Proposed Revisions to a Standard Plans Index

Originator:	Turley, Joshua	Index Number:	460-470
Date:	5/7/2024	Sheet Number(s):	1,3
E-mail:	Joshua.Turley@dot.state.fl.us	Index Title:	TRAFFIC RAILING - (THRIE-BEAM RETROFIT) TYPICAL DETAILS & NOTES

Summary of the changes:
Sheet 1: Added screw anchor details to the notes. Sheet 3: Added screw anchor option details to SECTION B-B

SECTION B-B

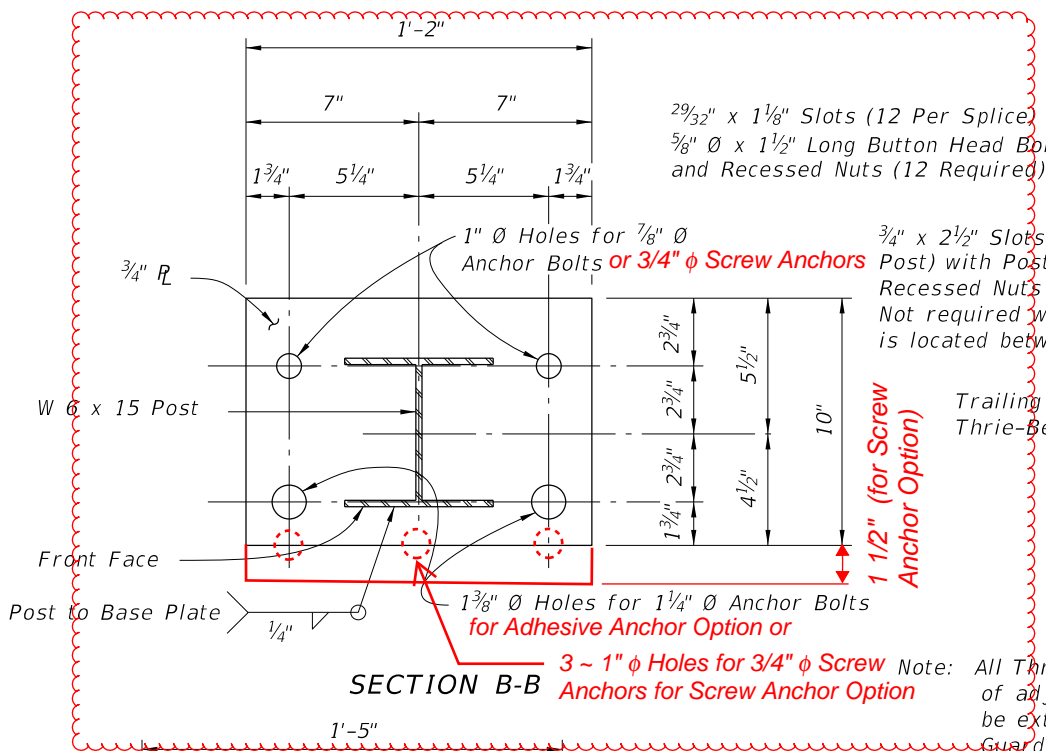
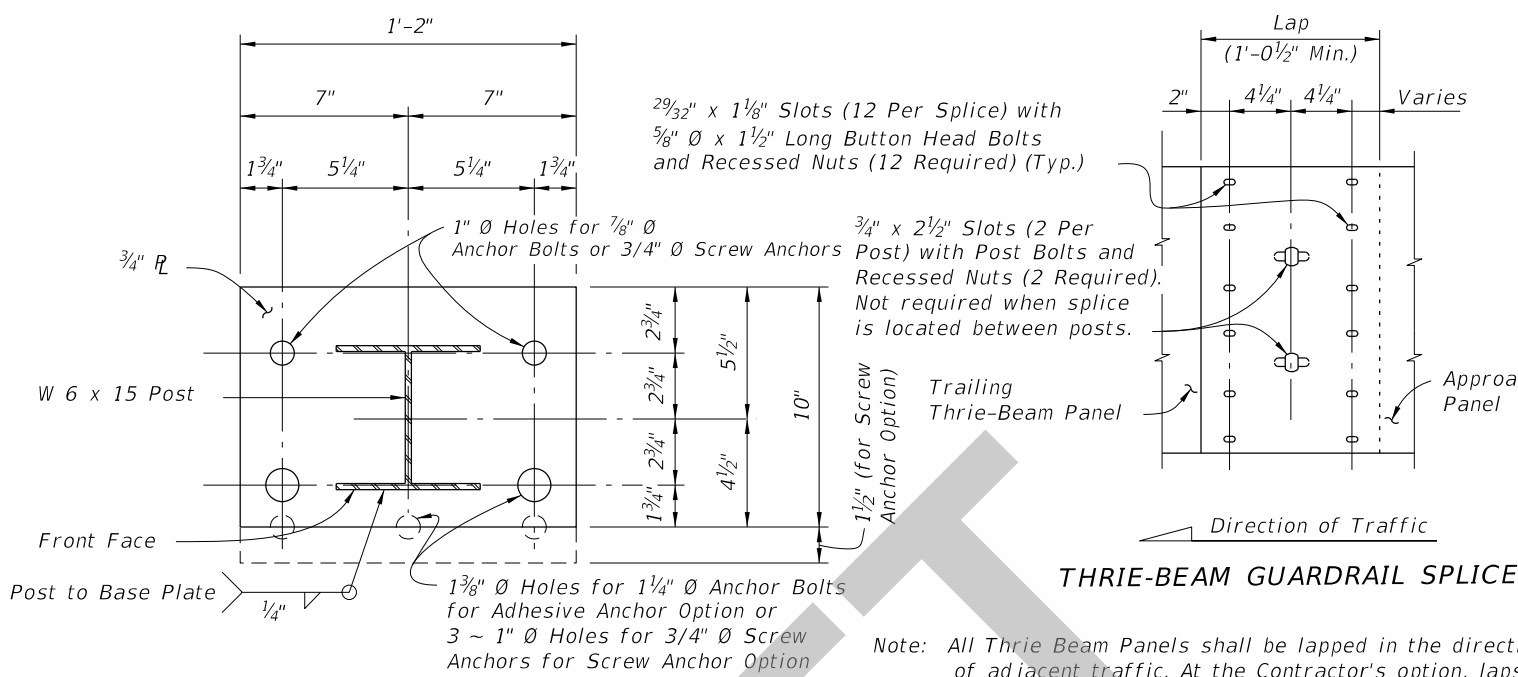
Commentary/Background:
Upon completion of new research we are allowing screw anchors as an option as an alternative to adhesive anchors.
